**GEOHYDROLOGY AND GEOCHEMICAL
REPORT and DOCUMENT REVIEW
of the
COTTER/LINCOLN PARK SUPERFUND SITE**

Colorado Citizens Against *ToxicWaste*, Inc.
P.O. Box 964
Cañon City, CO 81215

June 30, 2007

Patterson 2007
Figure 3f

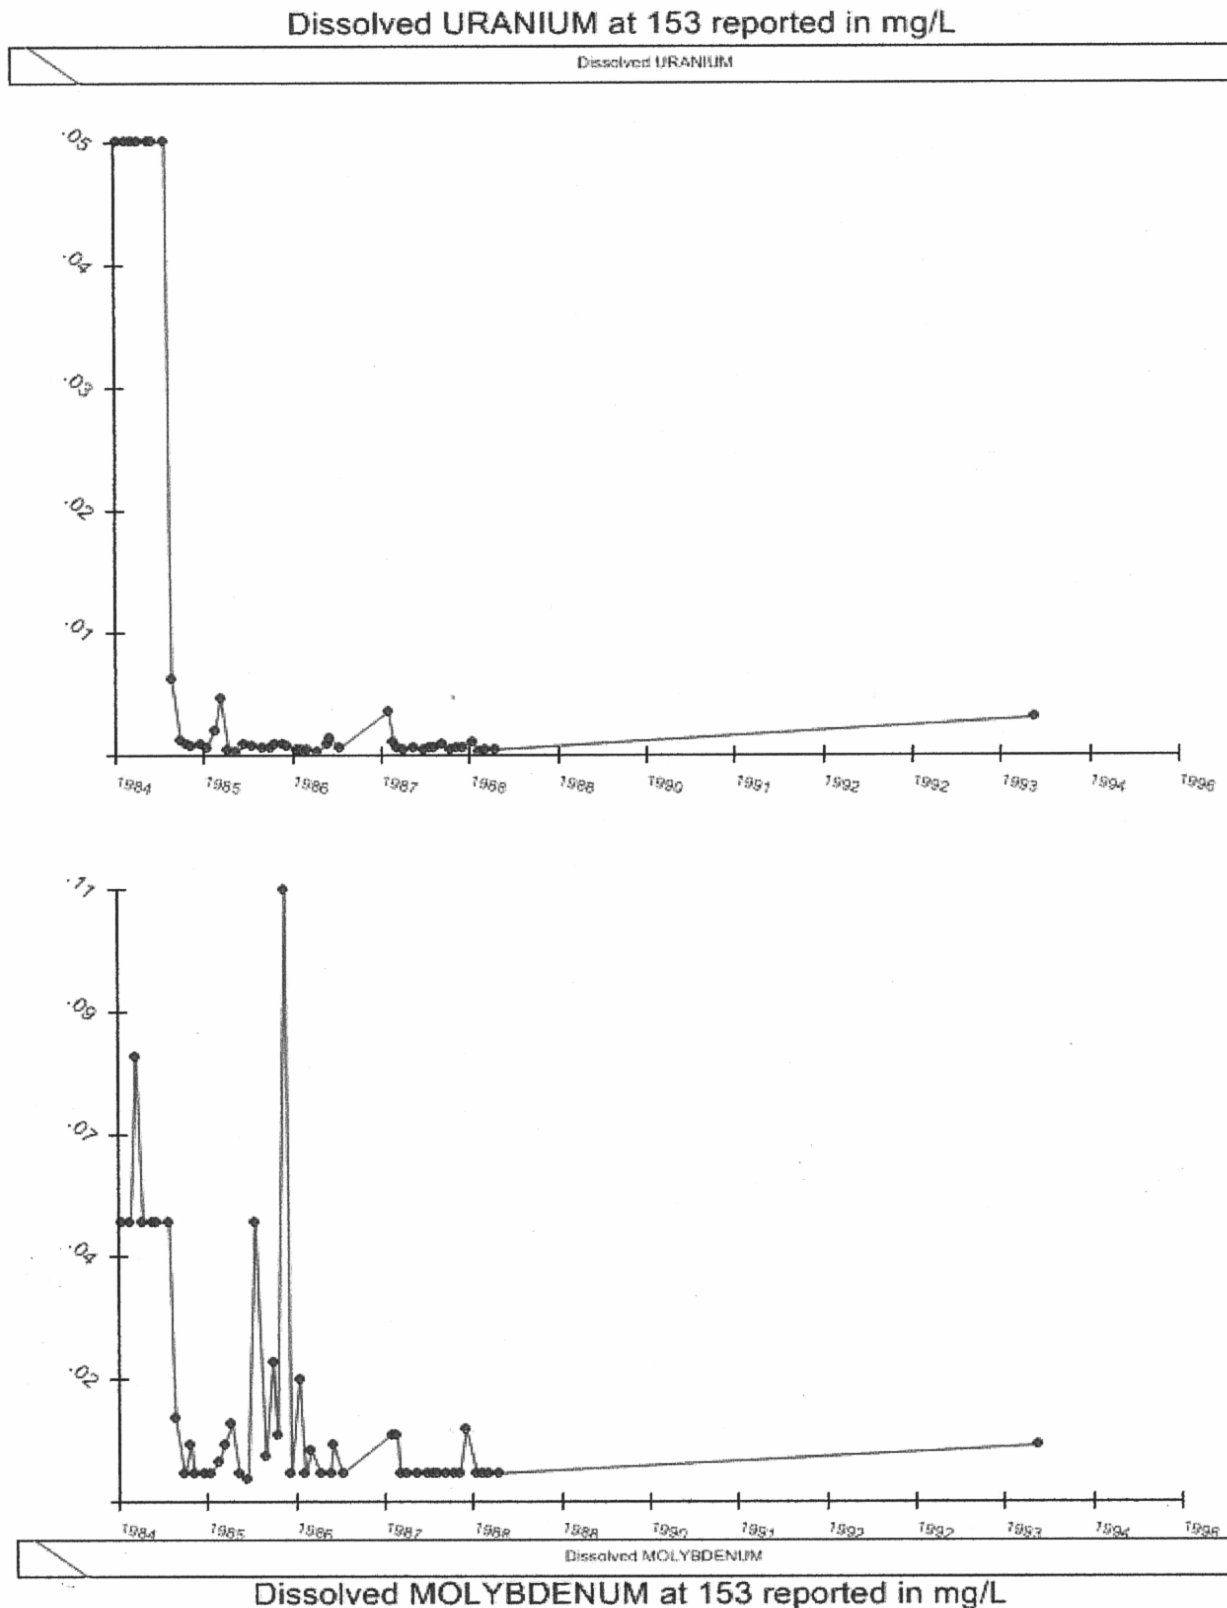
Well 006, discussed earlier, was drilled according to RAP standards to replace Well 138. Well 006 has shown what appears to be increasing levels of U, after a decline in the early 90's. The graph for Mo in Well 006 is omitted in Cotter's CY2005 Environmental Report and ALARA Review (Cotter, 2006), but more recent monitoring data shows that Mo is also well above the MCL and does not appear to be decreasing in Well 006 (Fig. 3f).

Well 006 appears to be increasing in U (Figure 3f) to levels around 0.5 mg/l (500 ug/l). It appeared to be leveling off to a steady-state of around 9.0 mg/l of Mo (9000 ug/l) until sampling in 2006 had a high of between 13 and 14 mg/l of Mo (13,000-14,000 ug/l).

- g. **Graphs for Well 006:** There is a significant omission in the text that has actually been carried through for the last few ALARA reports. On p. 7-12, the graph for dissolved Mo in Well 006 is not present and has been replaced by a duplicate of the U graph. This seems more serious as this is the most contaminated well, especially in Mo, off the plant
